**Clarification No.1 to Tender Document for Design, Engineering, Manufacture, Supply, Storage,
Civil Work, Erection, Testing & Commissioning of 5.76 MWp (DC) Grid connected Rooftop solar PV Plant including O&M of the Plant for a period of 5 years
(Tender No.GAIL/SECI/PC/W-171/SOLAR PV/2016 (E-Tender No. 8000010172))**

CORRIGENDUM NO. 2

Tender No. : GAIL/SECI/PC/W-171/SOLAR PV/2016 (E-Tender No. 8000010172)
Job : Design, Engineering, Manufacture, Supply, Storage, Civil Work, Erection, Testing & Commissioning of MWp (DC) Grid connected Rooftop solar PV Plant including O&M of the Plant for a period of 5 years 5.76

Ware House 1 Silo's Sketch

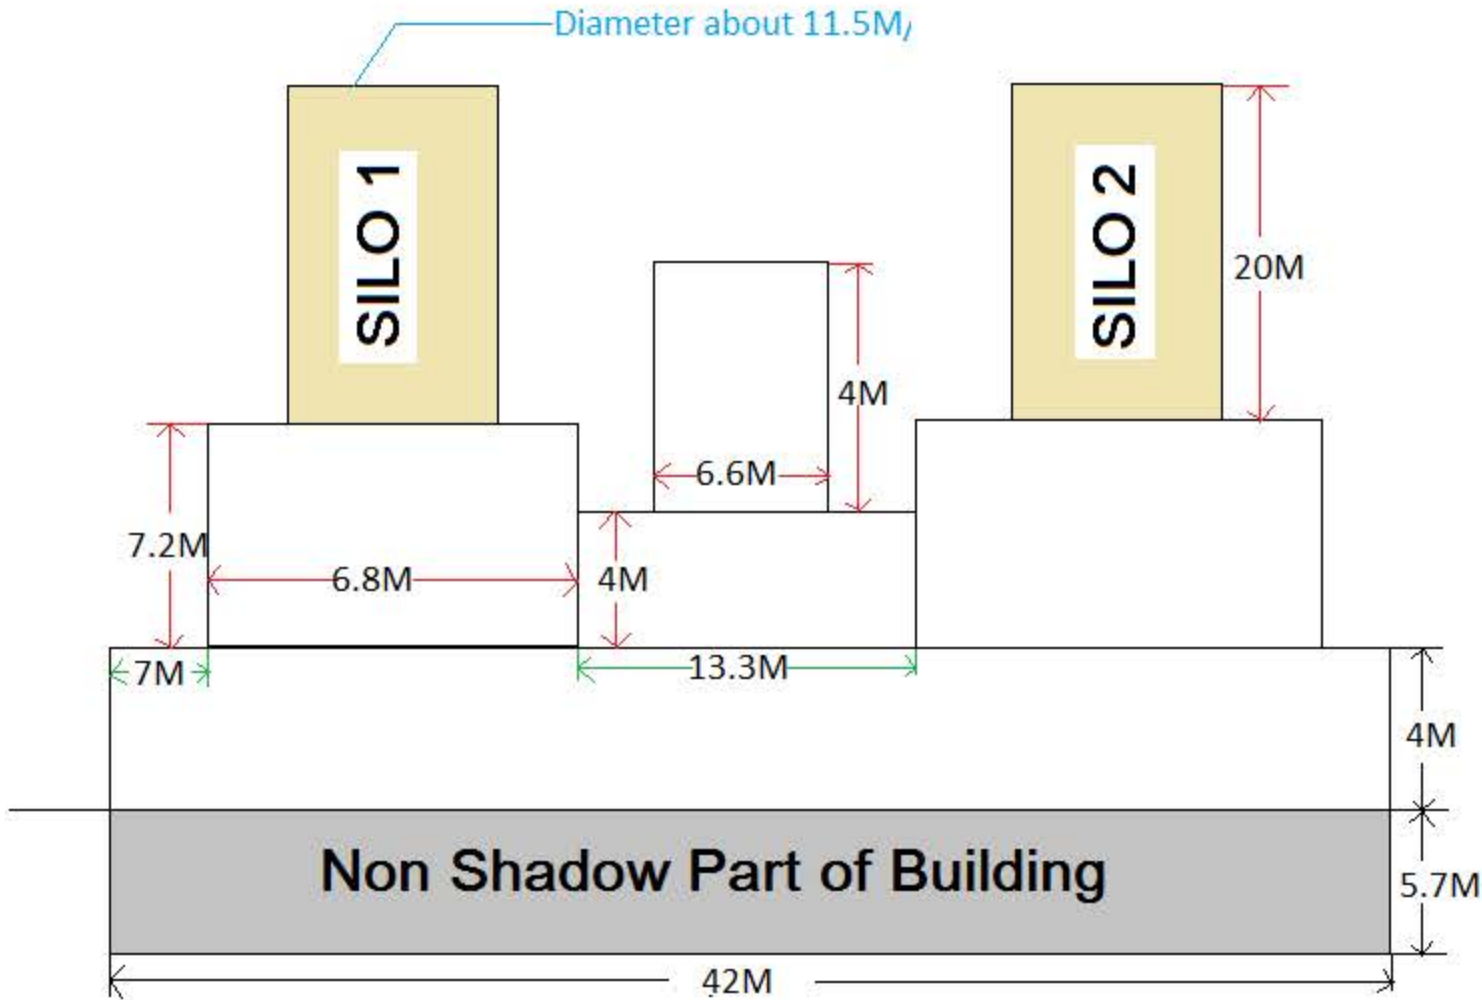
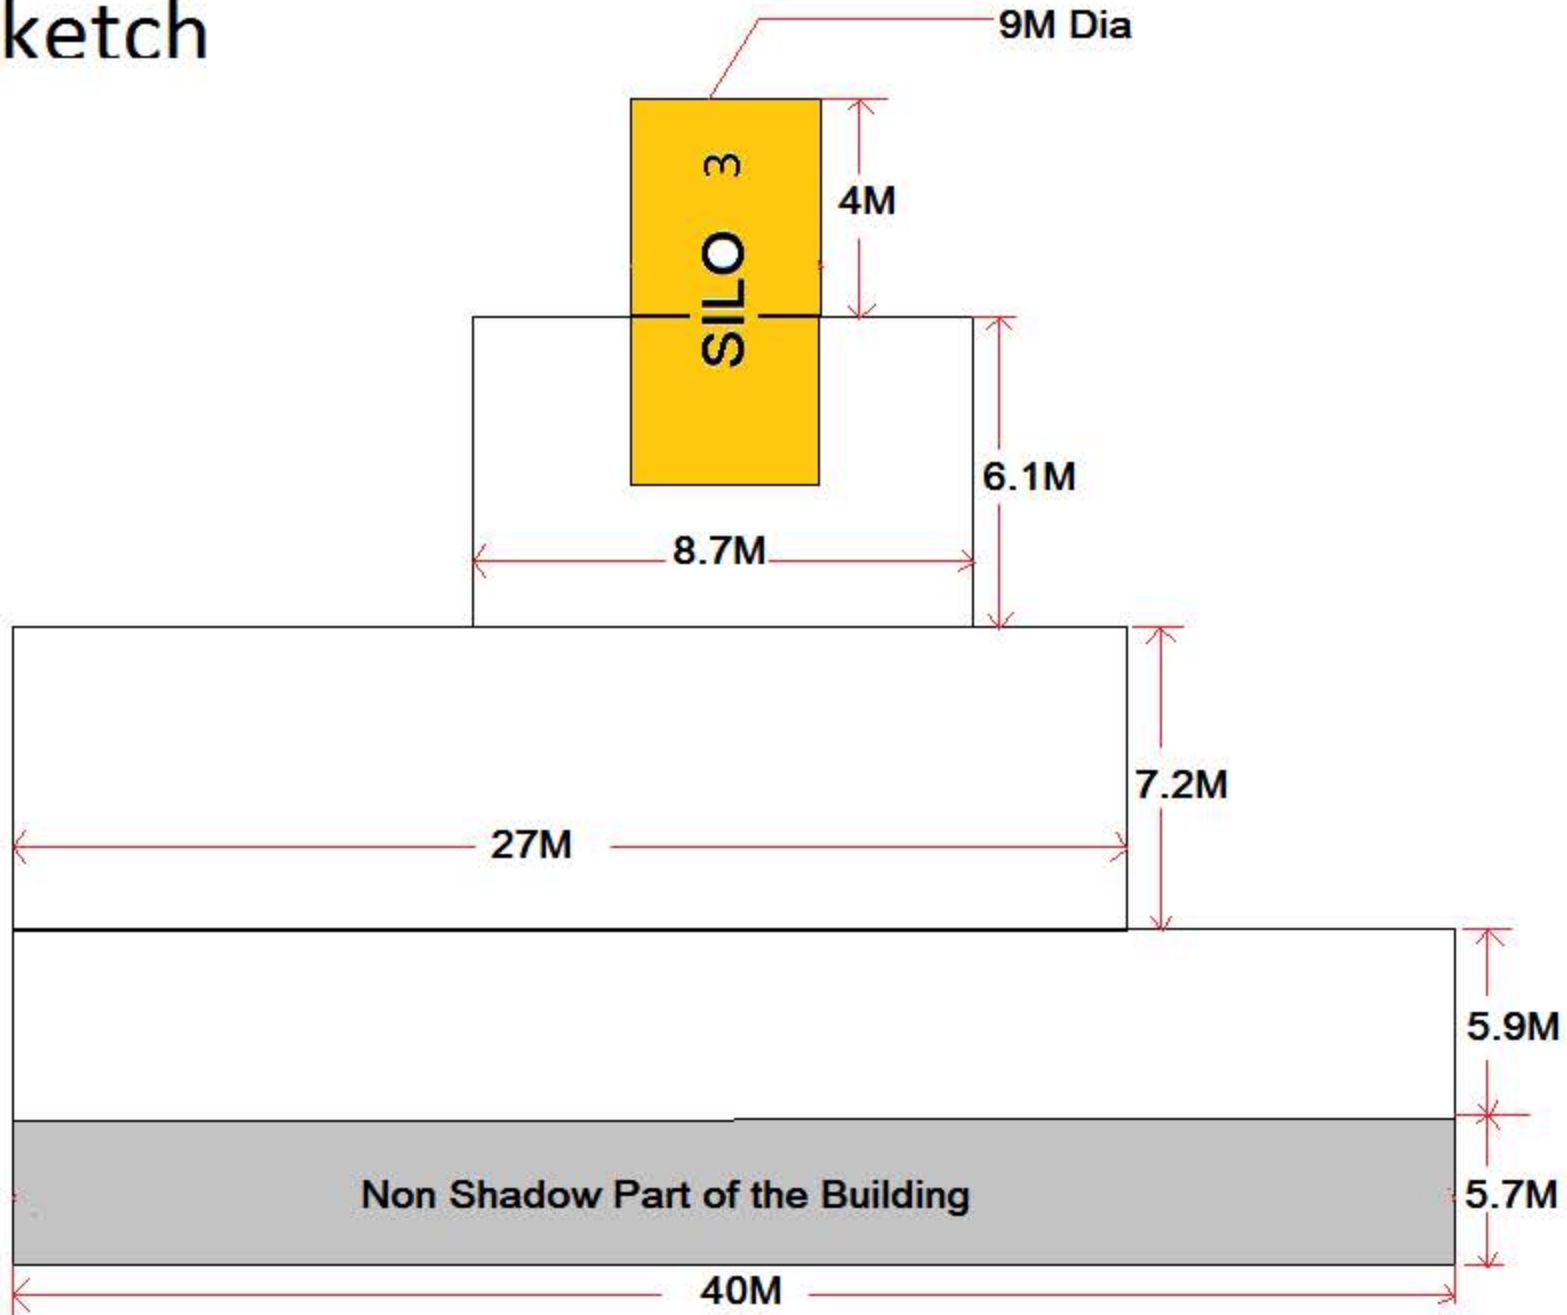
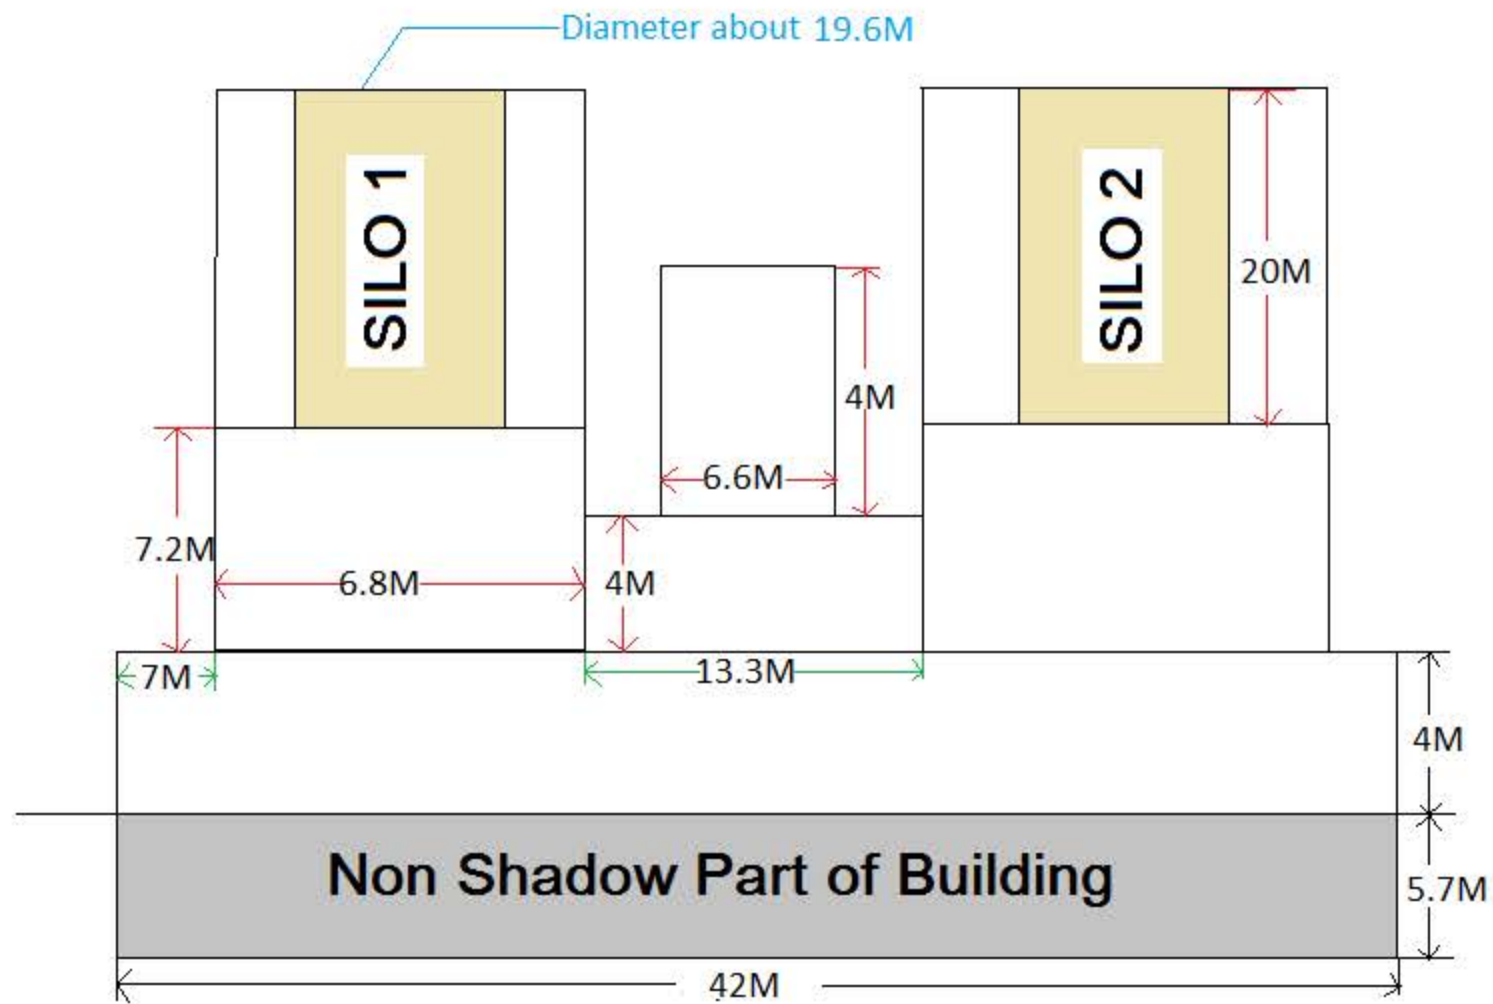
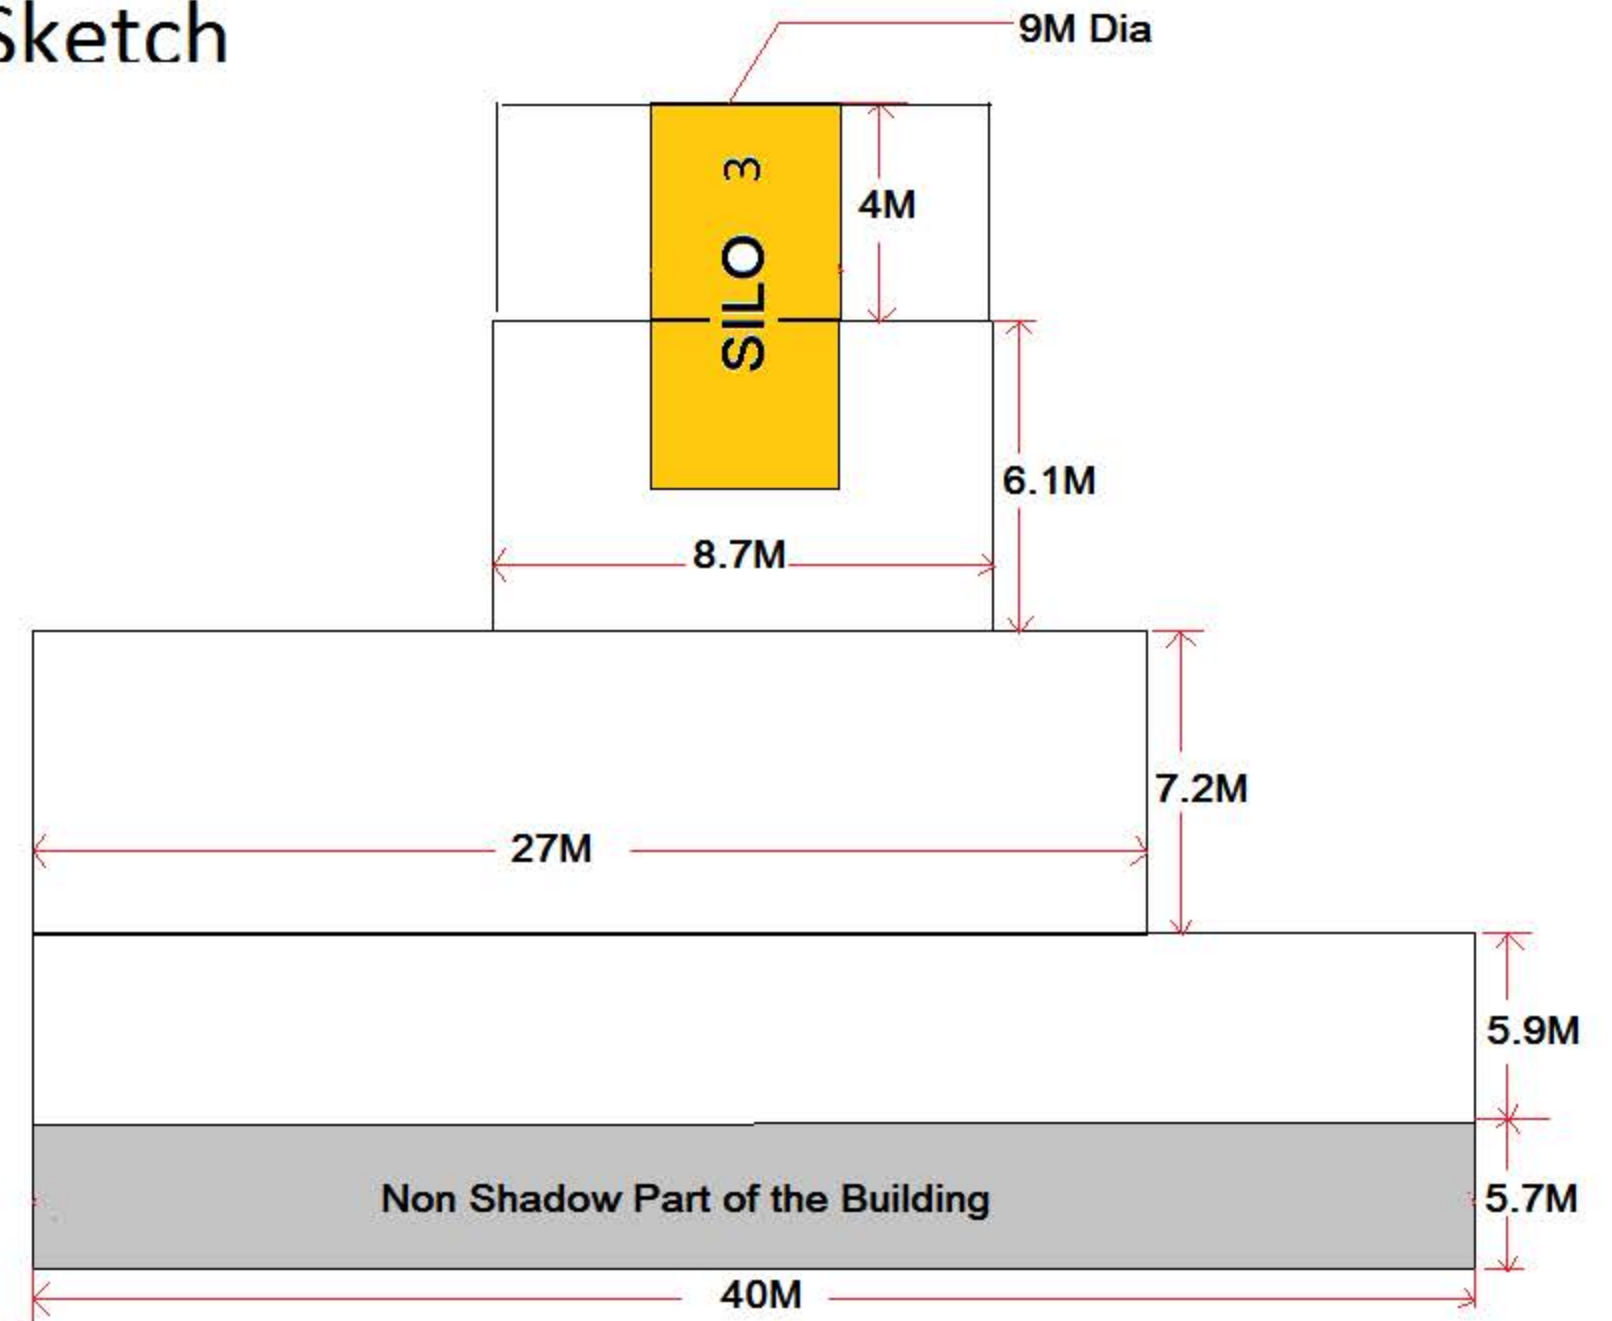
132	Formats	F22	132	General	Please confirm the stamp duty of Indemnity Bond .	As per prevailing rates in Delhi state.
133	General				Please provide Height of the Silos and Extruder for shadow analysis based on which plant capacity will be estimated	Please refer Corrigendum no.2
134	General			General	Fixing of structures will be on trusses/purlin & walkways on the sheet. Please confirm.	Bidder shall design the system as per prevailing good engineering practice with due approval from EIC.
135	General			General	Will road permit be issued	Yes, Employer shall issue the necessary road permit to the contractor.
136	General			General	Bidder requests that 5.76 MW DC shall be provided by bidder and AC will be designed so as to fulfil the functional guarantees.	The proposed 5.76 MWp SPV system is designed as per DC capacity only.
137	General			General	Switchgear, CT, PT, Meter at Feeder No. 19 side will be in scope of Bidder or GAIL, please confirm.	It is under the Bidders scope.

Sl. No.	Section	Clause	Sub-clause	Page no.	Modifications/Additions/Deletions
36	Section VI [Specifications, Scope of Work and Drawing]	30.7	--	96	RCC Works The typographical errors with respect to serial numbers of sub clauses are corrected and modified as under: 28.6.1 is modified as 30.7.1 28.6.2 is modified as 30.7.2 28.6.3 is modified as 30.7.3 28.6.4 is modified as 30.7.4 28.6.5 is modified as 30.7.5 28.6.6 is modified as 30.7.6 28.6.7 is modified as 30.7.7 28.6.8 is modified as 30.7.8 28.6.9 is modified a s 30.7.9
37	Section VI [Specifications, Scope of Work and Drawing]	--	--	--	Drawings & Documents: Further to Annexure- I & II, the following Annexures are added: Annexure III: PTD Warehouse Drawings Annexure IV: Drawings related to Silos height

Total 3 Silo's Height of Silo 1 & 2 - 37 Meter
 Height of Silo 3 - 29 Meter

Total 3 Silo's Height of Silo 1 & 2 - 37 Meter
Height of Silo 3 - 29 Meter
